Development Review Division

Community Development Department: *Town Hall / 20120 East Mainstreet Parker, CO 80138* Phone: 303.841.2332 Fax: 303.841.3223

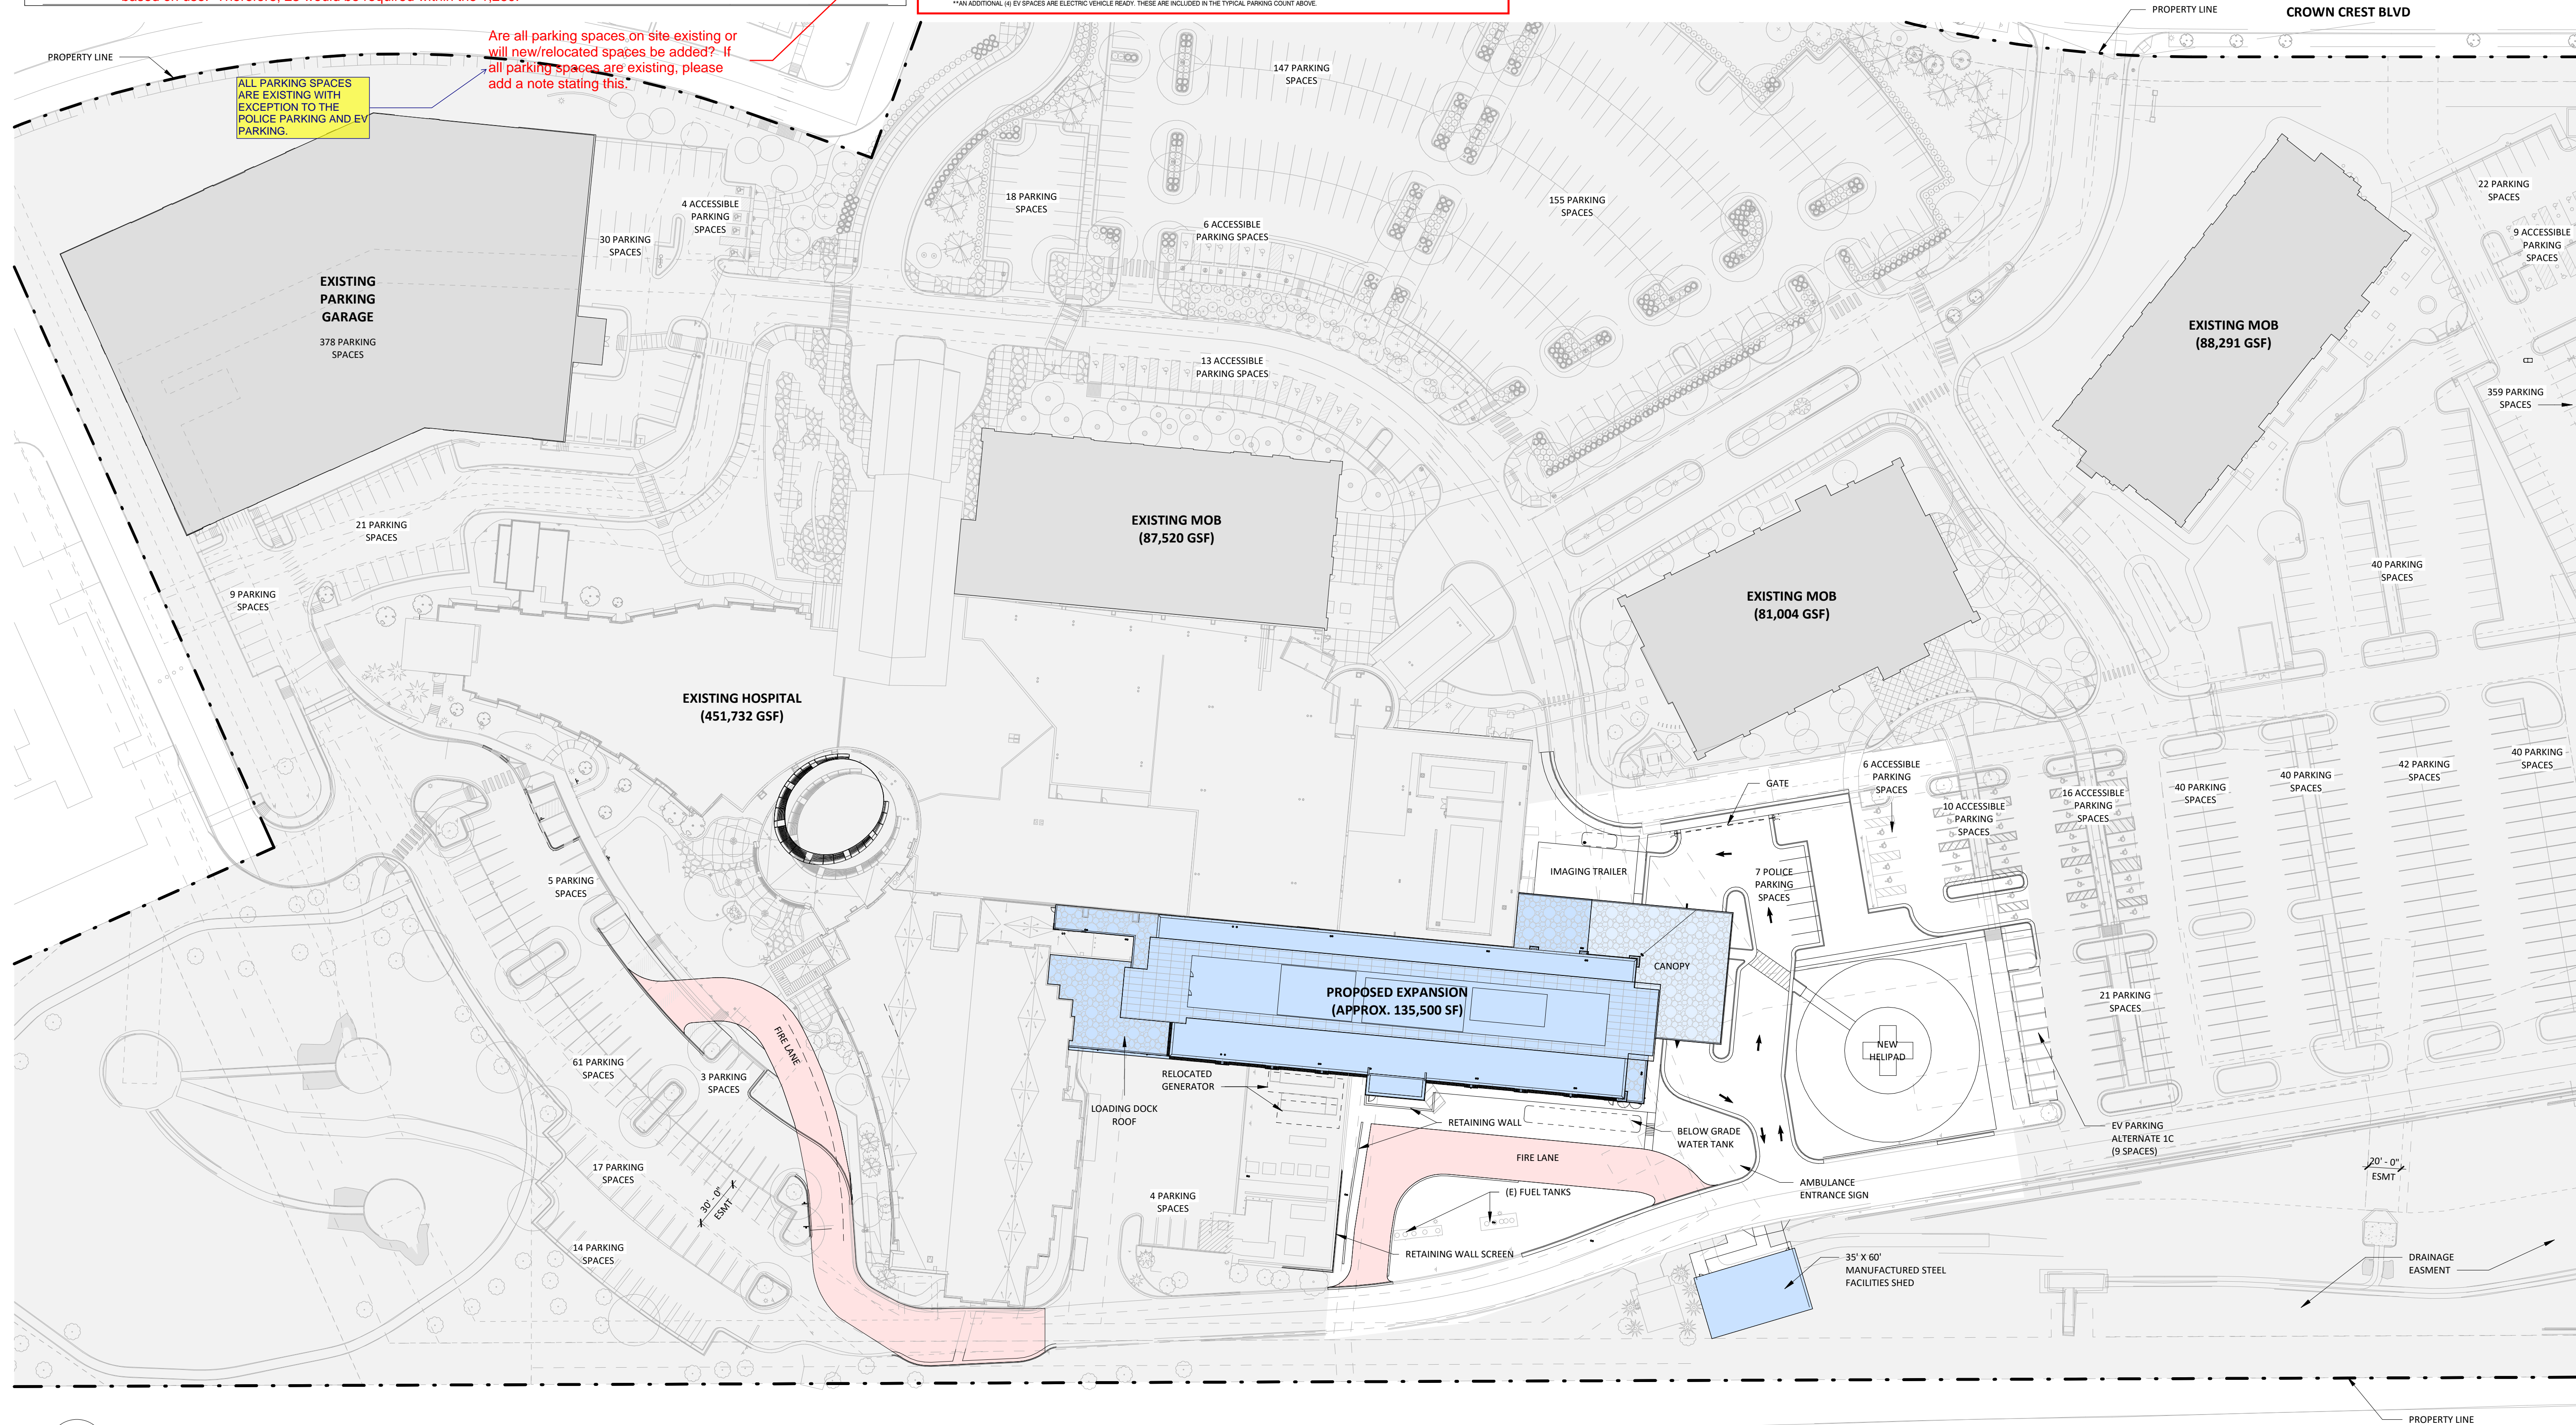
This has been revised to not include the additional ADA stalls in the overall required count.
